# Addendum No. 1

**Project:** Fort Wayne International Airport  
Construct Taxiway G Extension & Demolish Taxiway C2  
AIP No. 3-18-0022-71

**Date:** June 14, 2024

Drawing No.: **D1.1.1**

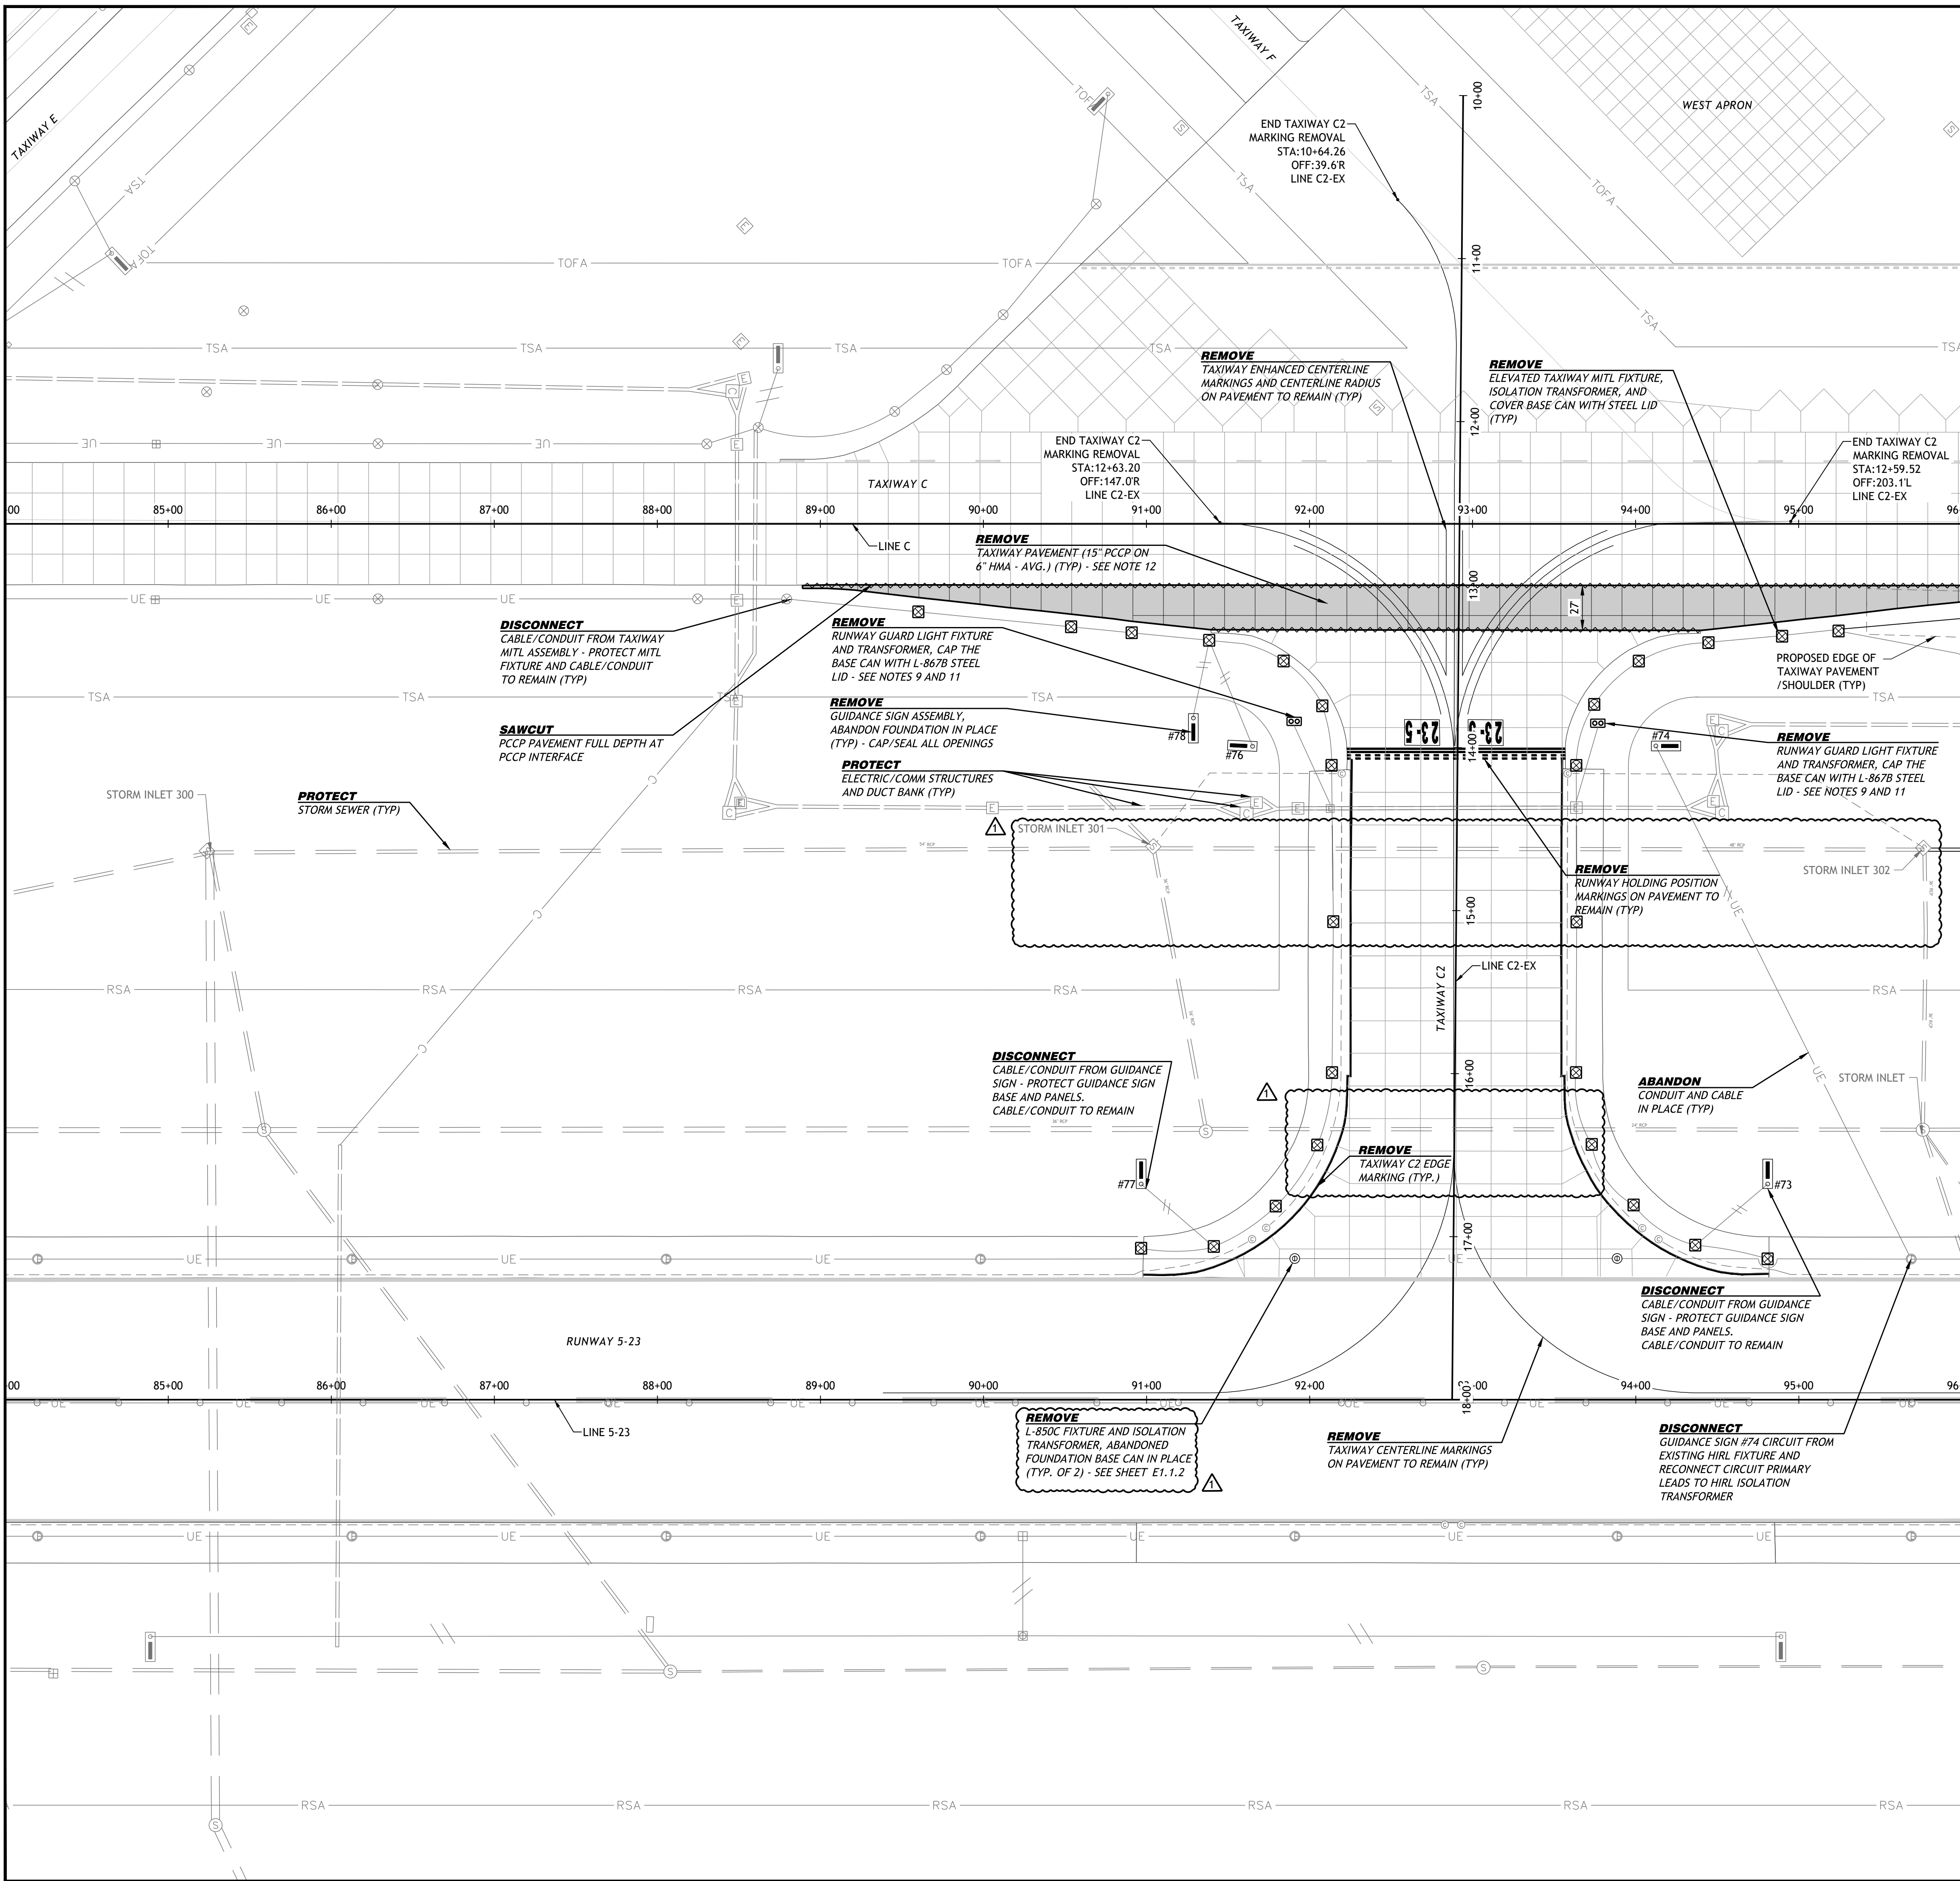
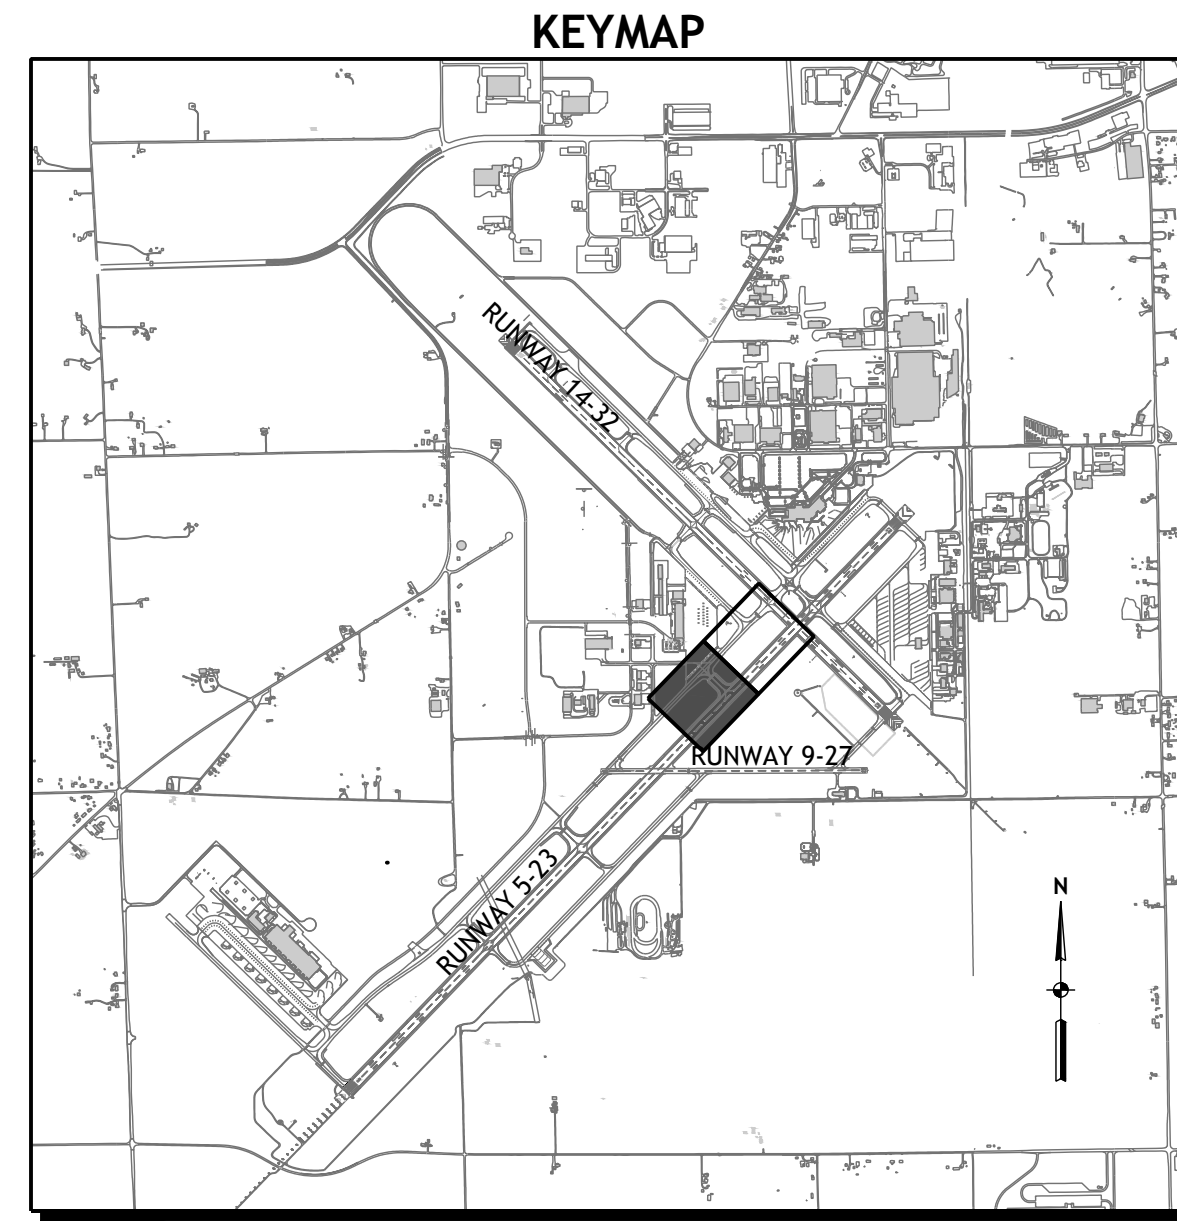
An action note callout has been added to call for removal of edge markings on Taxiway C2.

Runway guard light (RGL) fixture removal and base can steel lid note revised to reference L-867B in lieu of L-868.

Drawing No.:  
**C1.1.6**

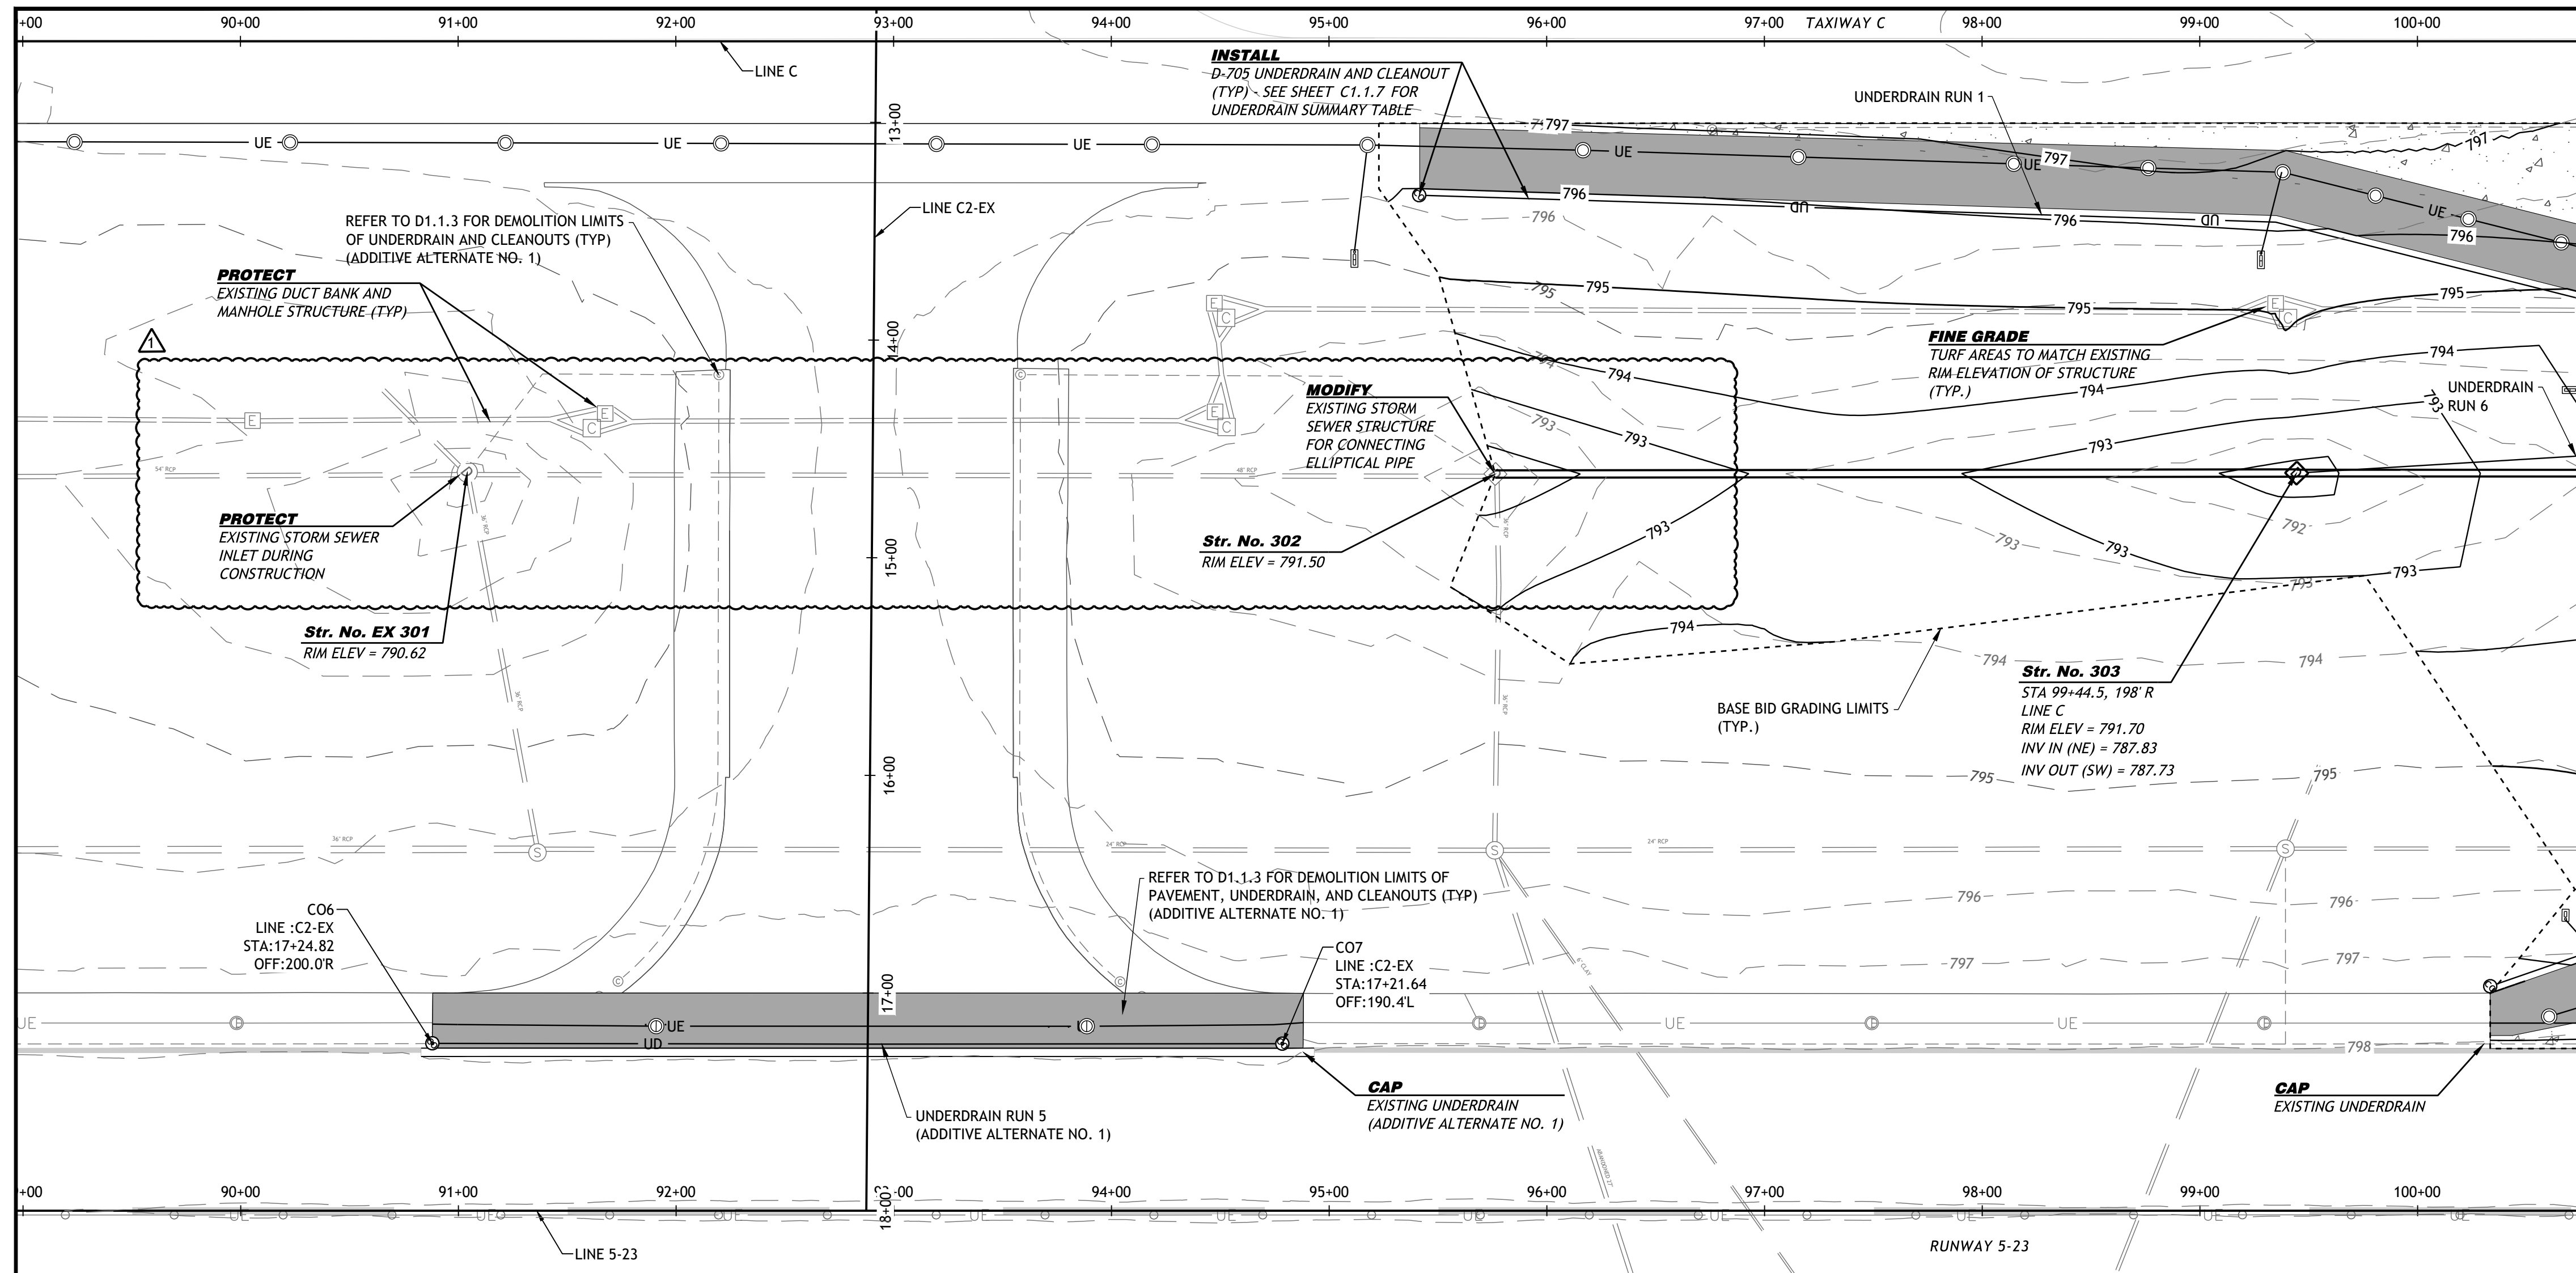
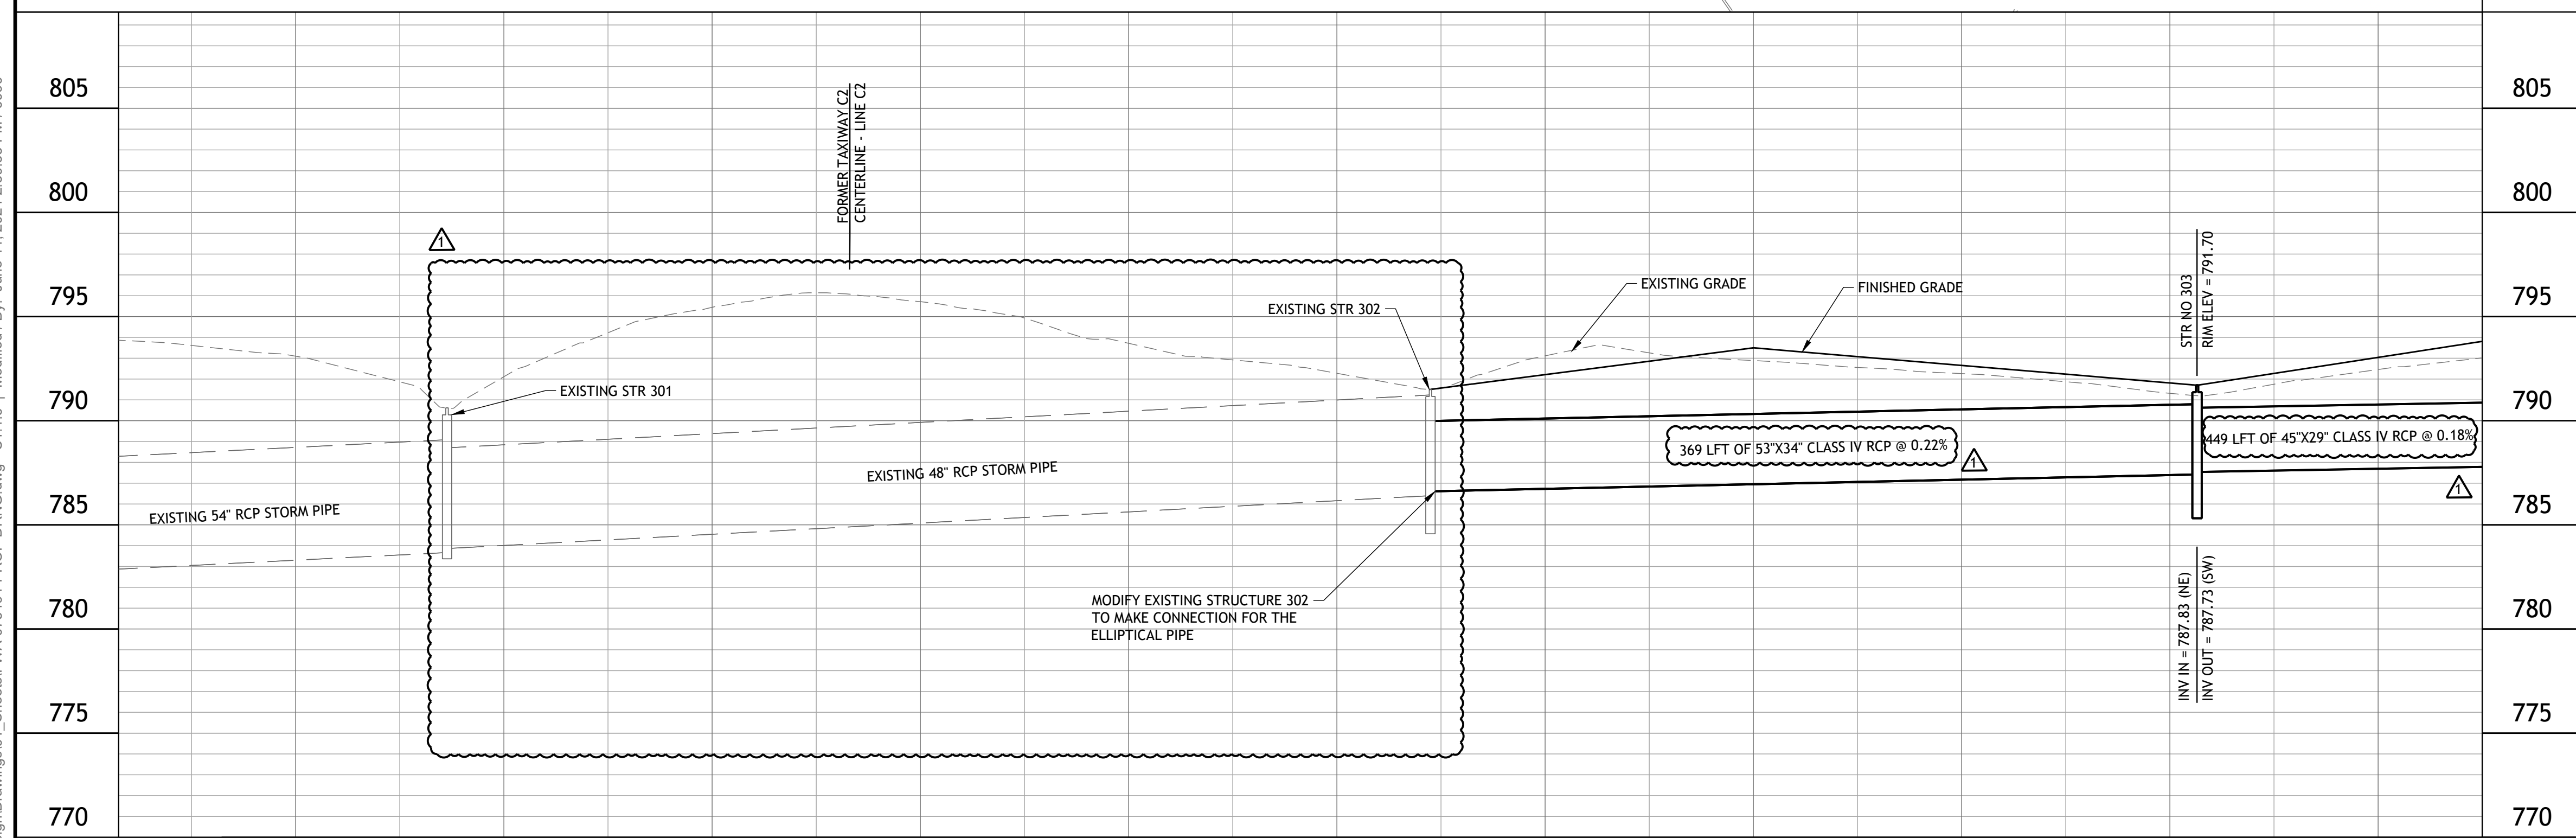
Reissued: Revision to storm sewer pipe plan has been provided to reflect re-use of existing 48-inch storm
